SOLICITATION ADDENDUM NO. 3 ITB 19-0037 2020 Auditorium Upgrades

Drawing and Specification Revisions

The following documents are a part of Addendum 3 to ITB 19-0037 2020 Auditorium Upgrades. These documents indicate changes to Attachment K Drawings and Attachment L Specifications.

AUDITORIUM FLOOR PLAN LEVEL 1 ELECTRICAL

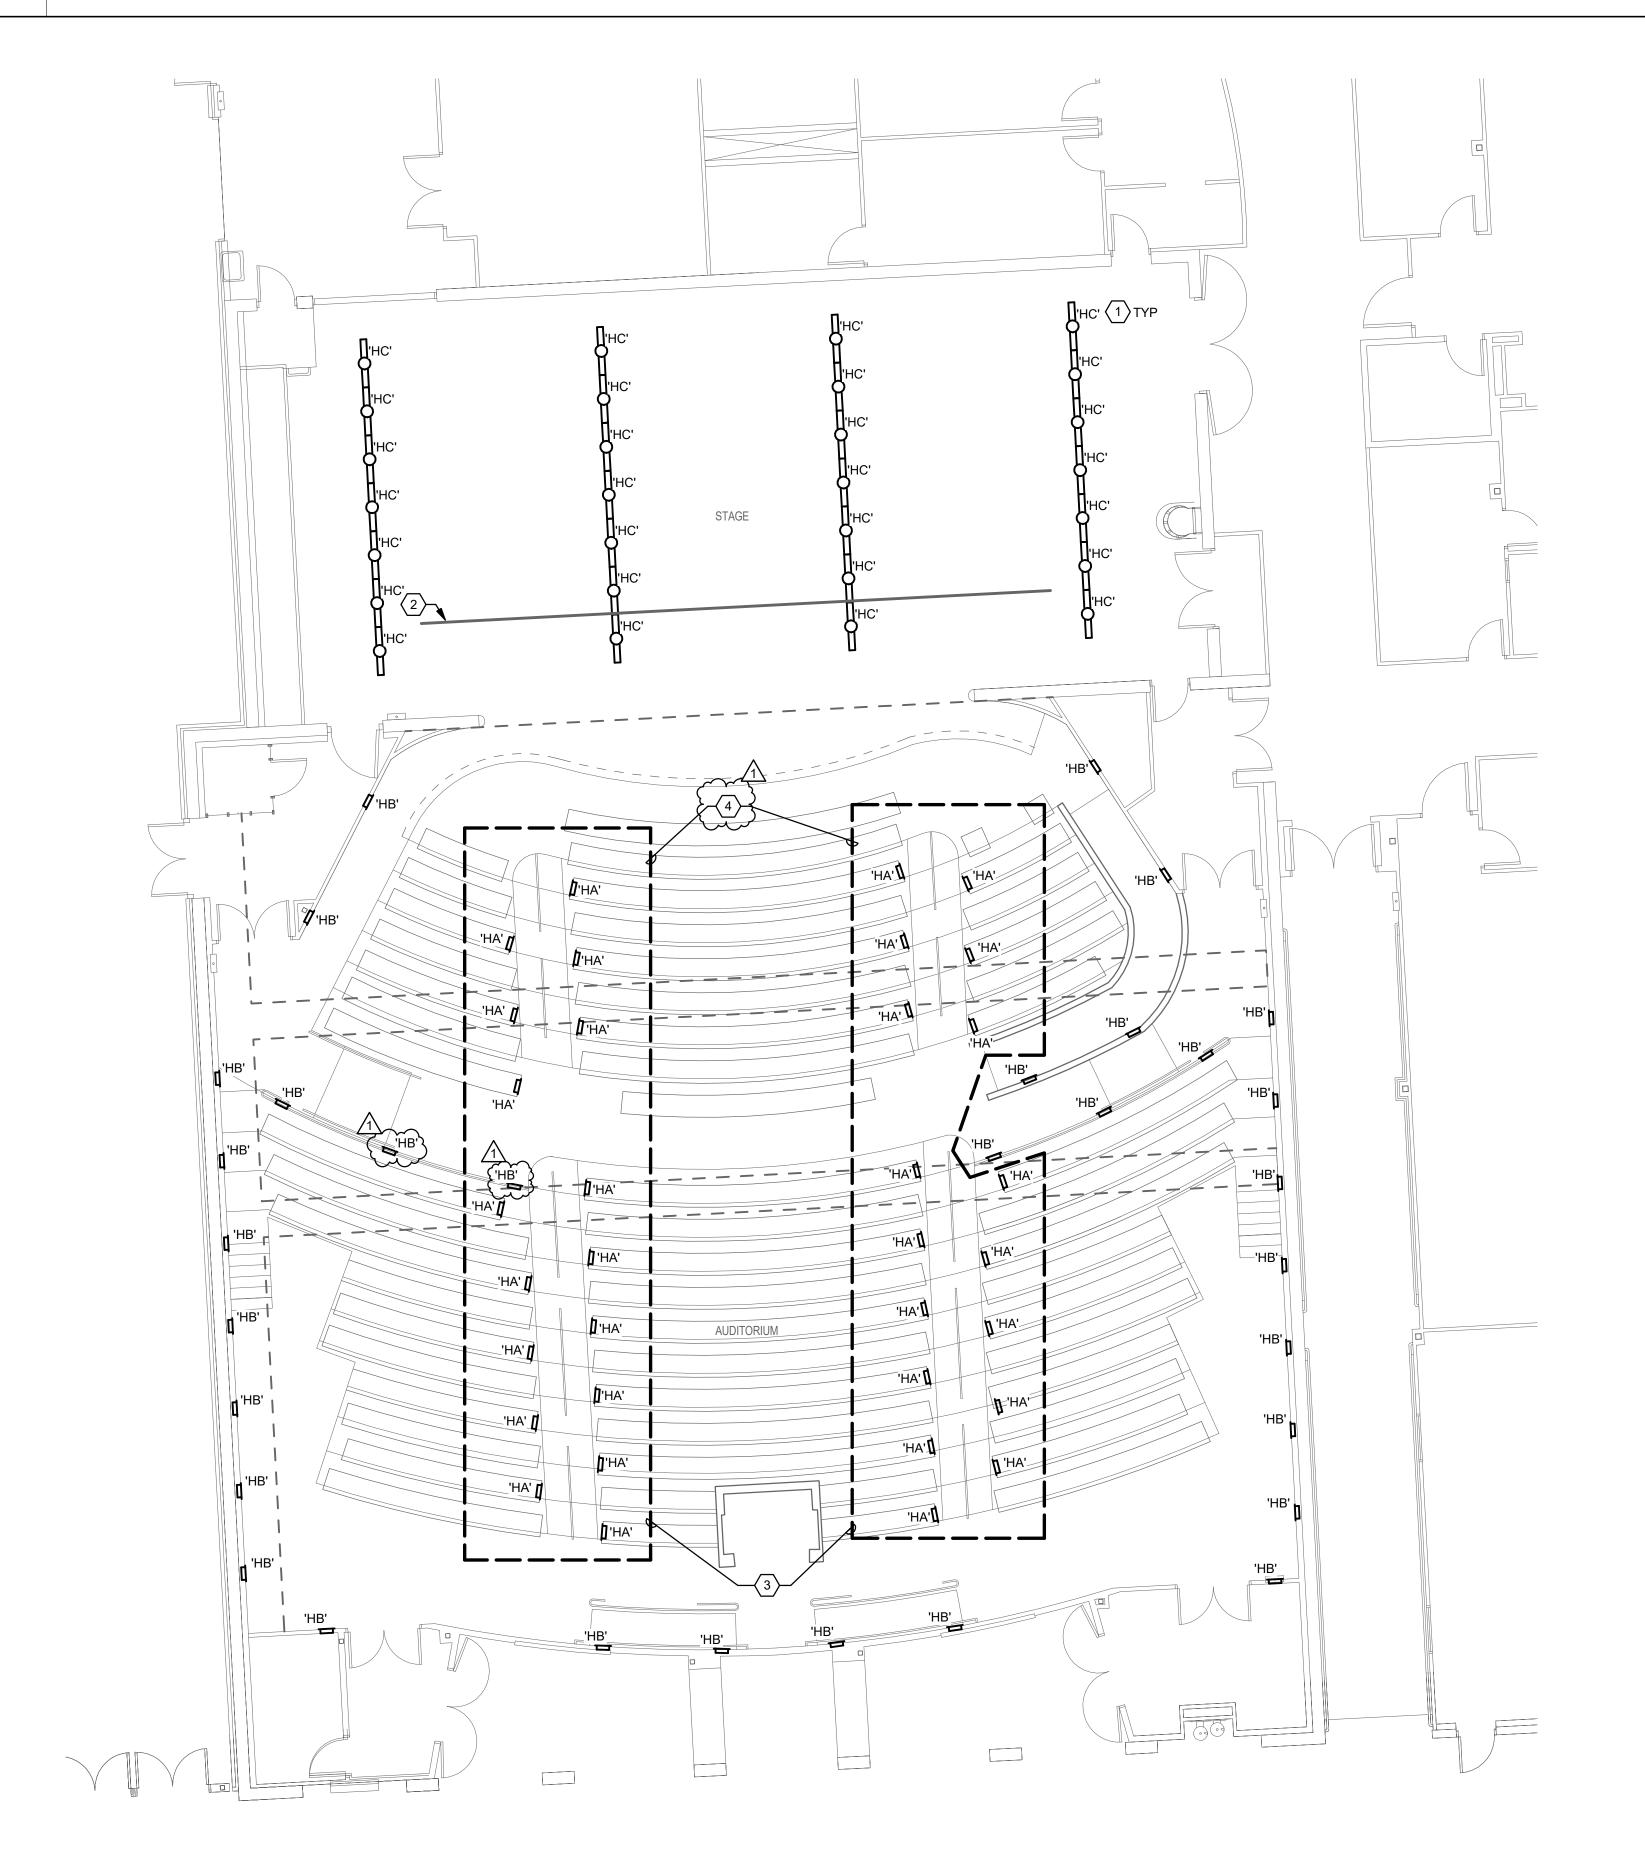
Sheet E2.1 Added sheet keynote 4, to indicate to rewire aisle lighting onto separate dimmer from house lighting.

Added two step lights to existing locations to be replaced below railing.

4. SEPARATE AISLE LIGHTING FIXTURES ONTO DEDICATED DIMMER, SEPARATE FROM HOUSE LIGHTING.

AUDITORIUM FLOOR PLAN LEVEL 1 ELECTRICAL

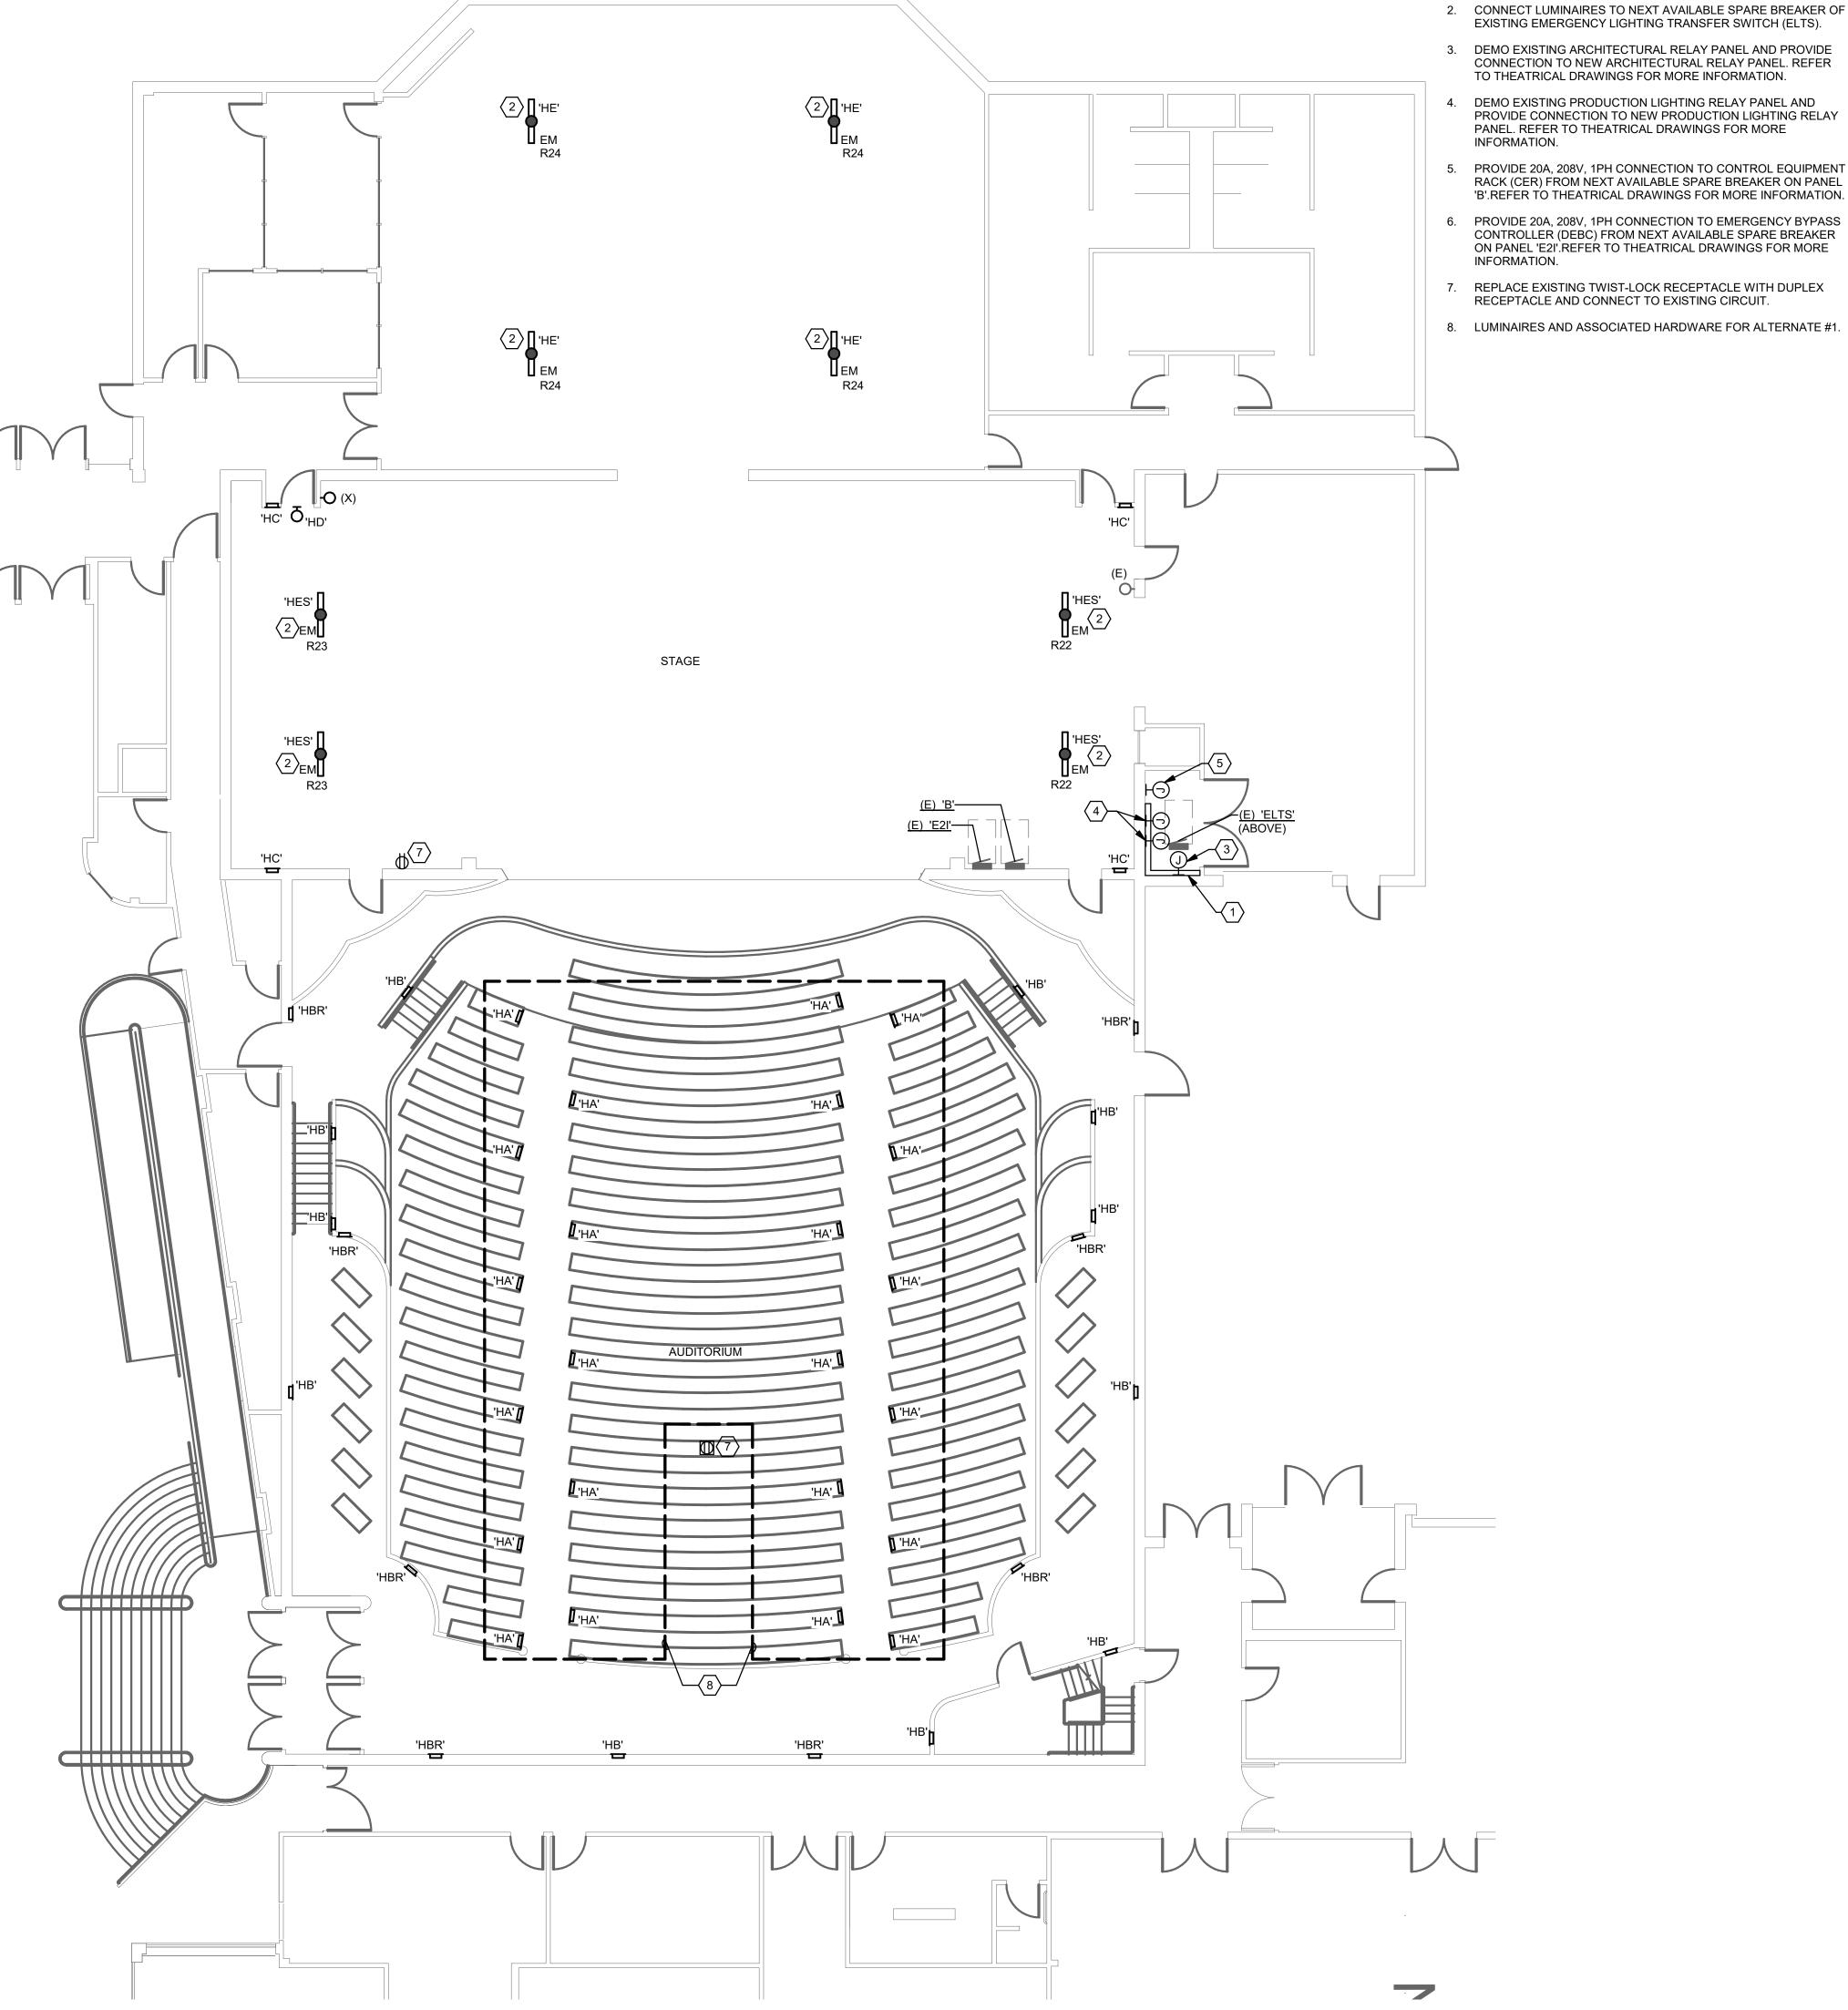
Sheet E2.1 Revised listed manufacturer/model number for luminaire types 'HD', 'HE', and 'HES' in luminaire schedule.
